RE: Rebuttal Information for Land Use File
LU 16-159330 LDS EN
(*Hearing Continued from 6/22/17*)

The Hayhurst Neighborhood Association voted to submit this rebuttal letter at our July 10, 2017 meeting. We challenge the February 2017 Hayhurst School Safe Routes to School Map placed in the record last week.

1/17/2014

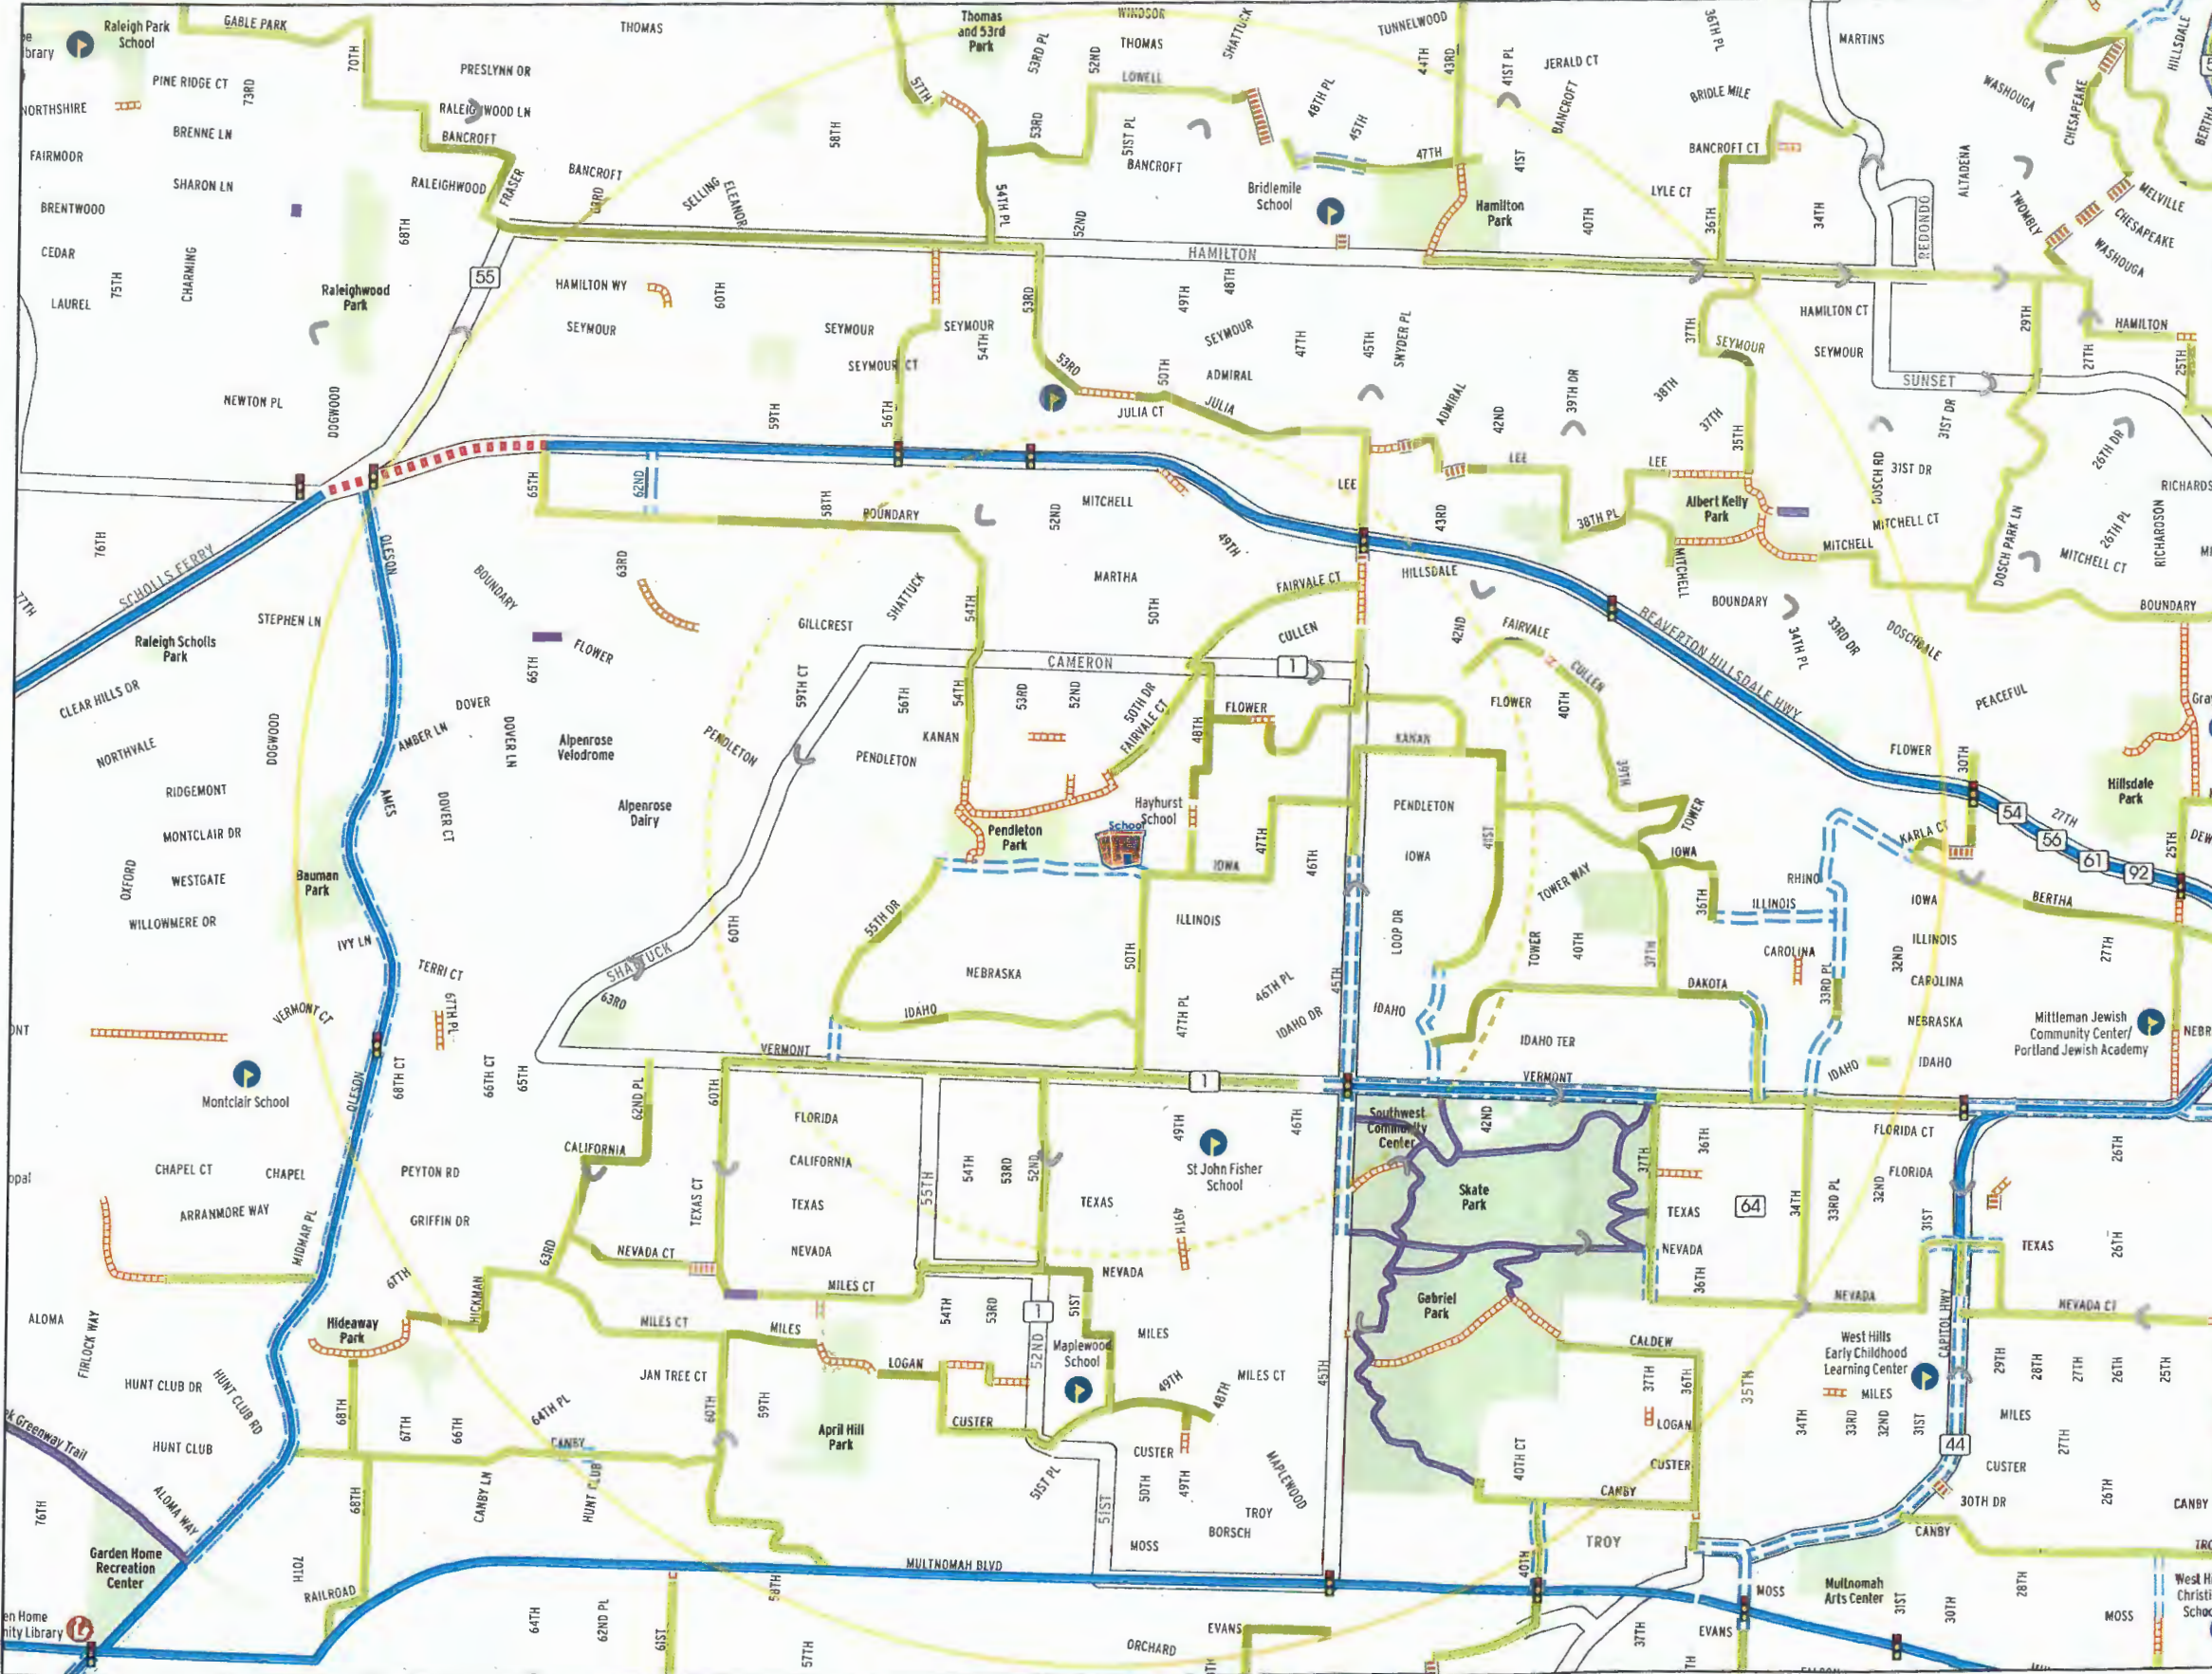
Hayhurst NA testifiers who presented information at both the March 8, 2017 public hearing and June 22, 2017 appeal hearing placed the Safe Routes to School map dated January 17, 2014 into the hearing record. We ask that the City Council consider the January 2014 as the most relevant to neighborhood concerns regarding the safest way for children and parents to access Hayhurst Elementary by walking. The January 2014 map highlights SW 48th Ave between SW Cameron Road and SW Iowa St as a Safe Route to School. Preserving SW 48th Ave as a SRTS is a high priority for our neighborhood association.

Updated: 2/25/2017

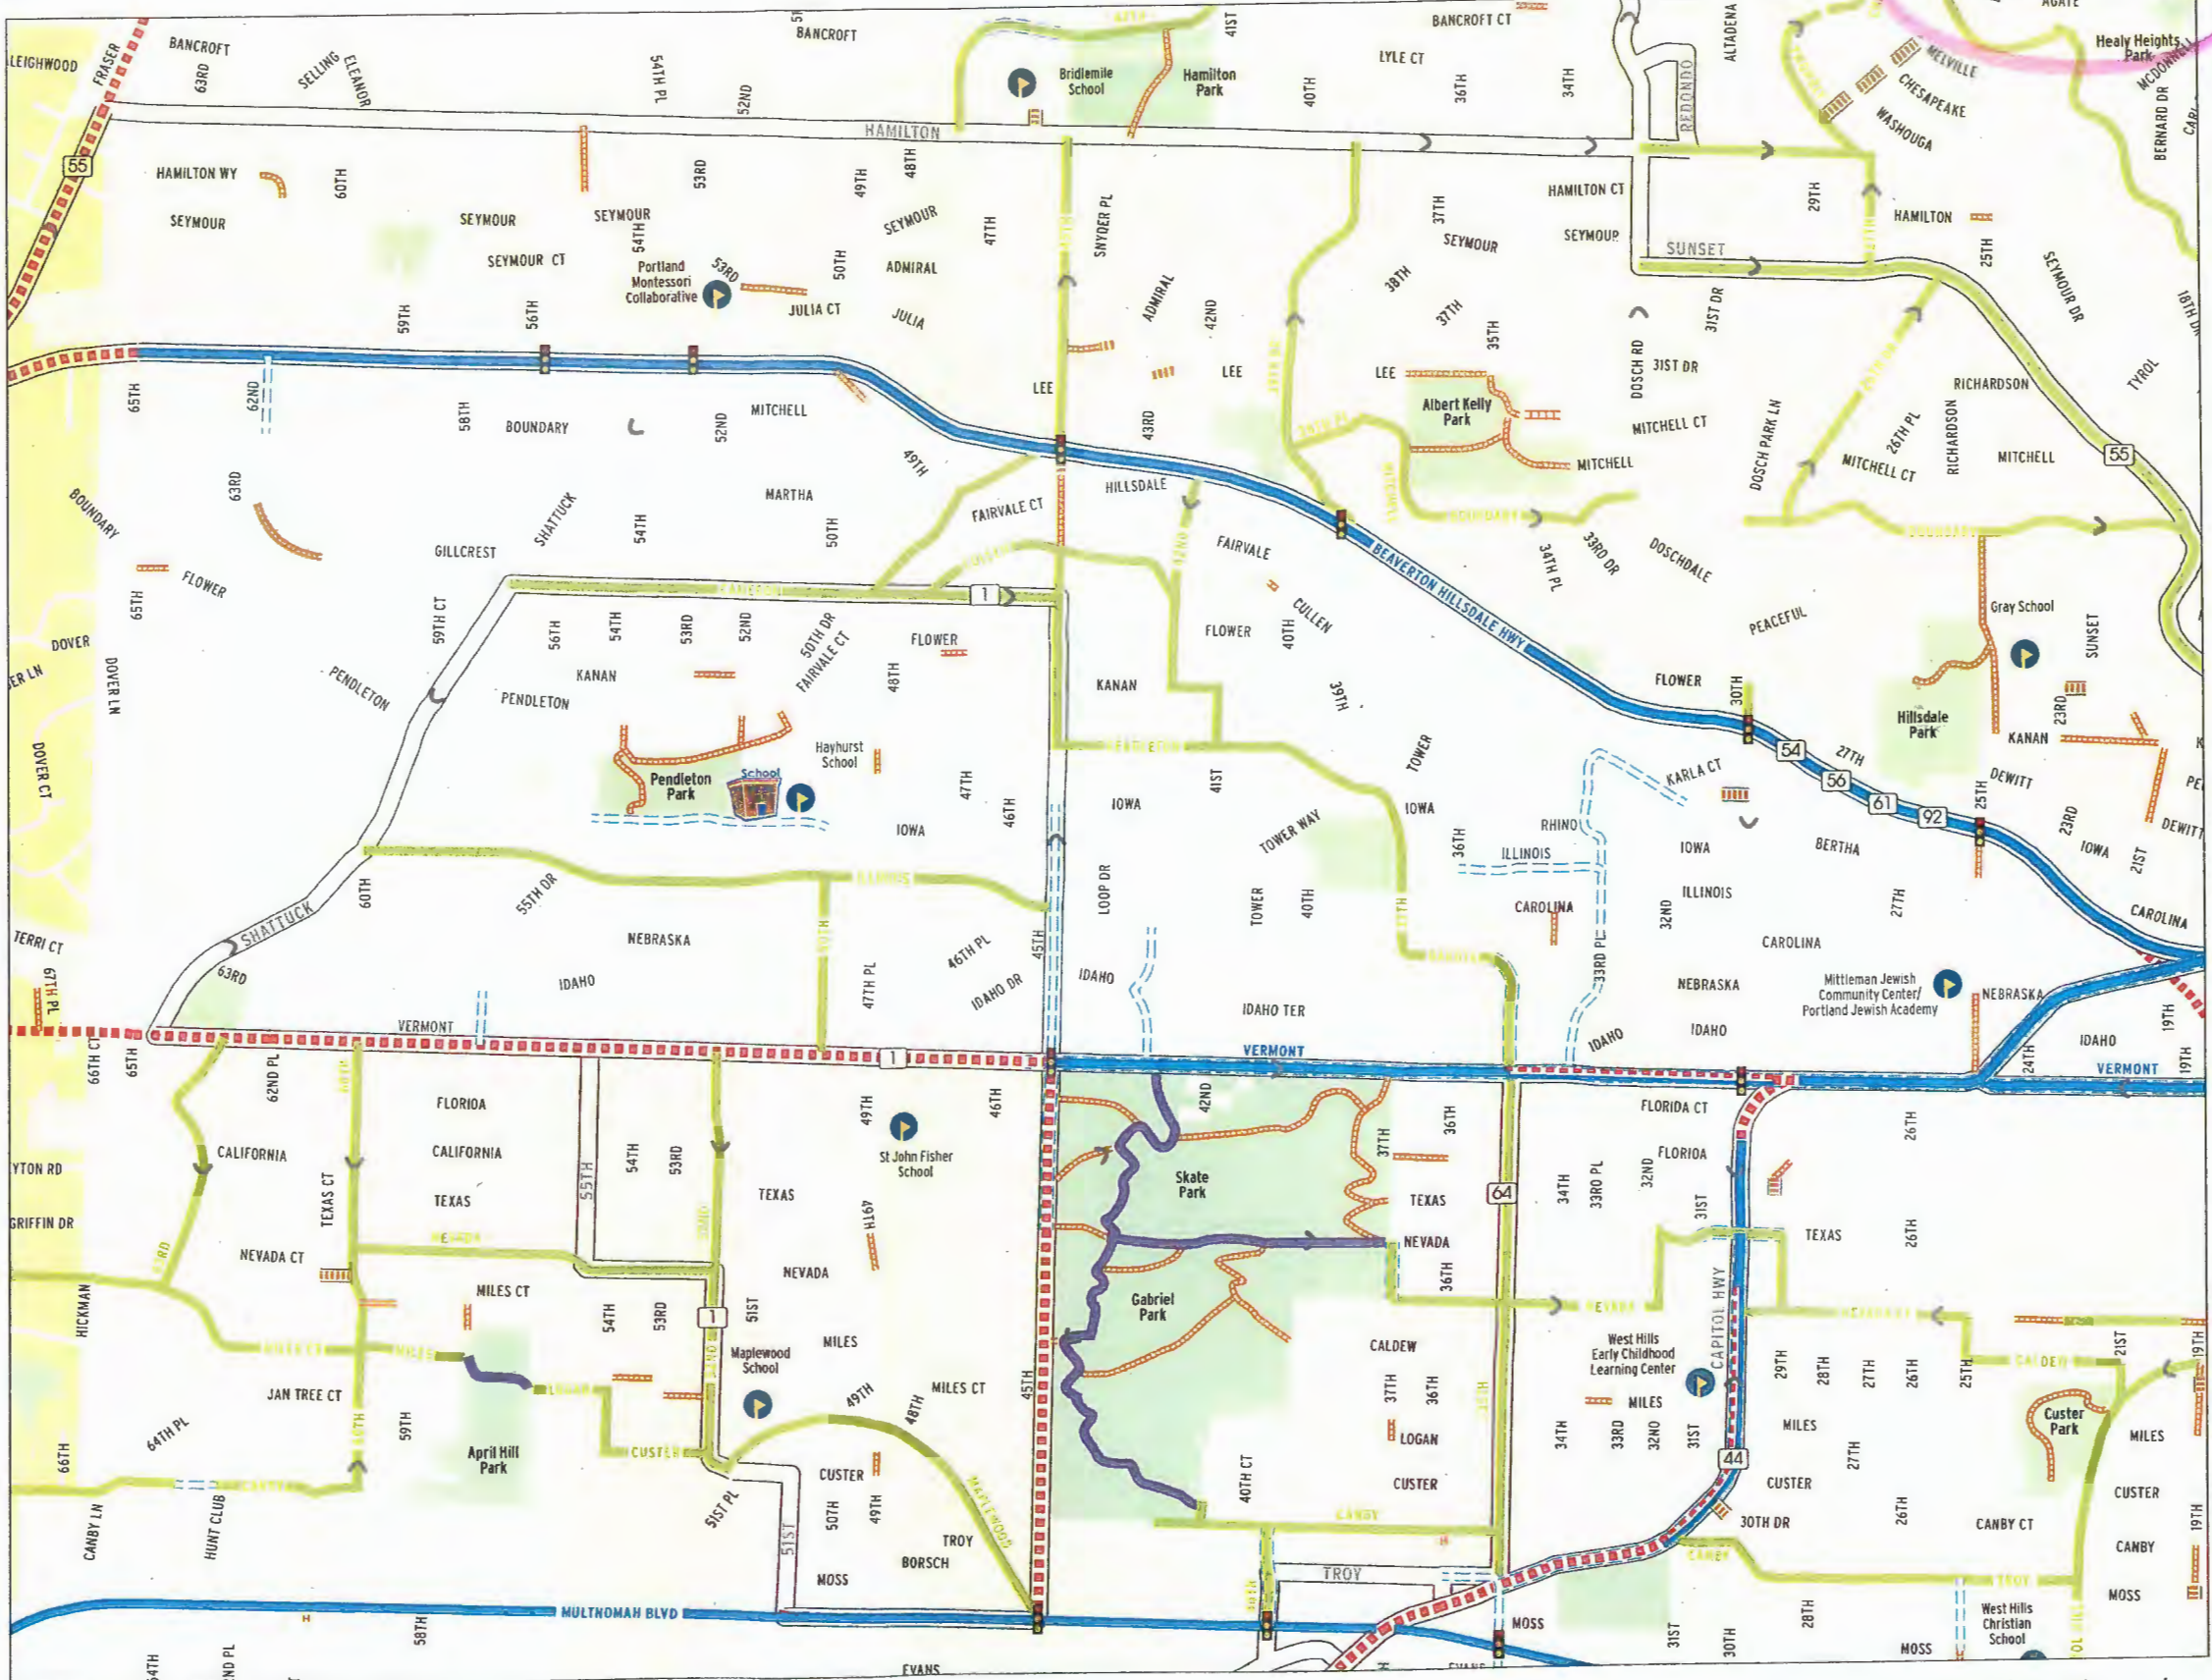
The two Safe Routes to School maps (January 2014 & February 2017) are included as attachments to this letter. The February 2017 SRTS map has serious deficiencies, including showing SW Cameron Road as a SRTS with no designated south bound access points to the school from SW Shattuck to SW 45th. Cameron Road is dangerous street for pedestrians because it has no sidewalks and only narrow shoulders that leave little safe walking space. In addition, many cars travel above the posted 30 MPH and PBOT has conducted traffic studies over the years to deal with speeding issues. We

feel that this route will put school children and parents at serious risk for pedestrian crashes.

We notified Janis McDonald, with the Safe Routes to School office, on July 6, 2017 to ask that the February 2017 map be corrected. Ms. McDonald responded by saying the new map had mistakenly used an older bicycle route for the neighborhood versus the accurate Hayhurst School SRTS route. Another validation of SW 48th as a SRTS is that the current 2017 Southwest Portland Bike/Walks Map (May 2017) shows 48th as a safe route. Ms. McDonald stated via email that the Hayhurst SRTS map would be "recreated." With this in mind, we request that City Council disregard the map submitted by Ms. Beckman, dated February 2017, and use the January 2014 Hayhurst School Safe Route to School map as the only reference point for their deliberation
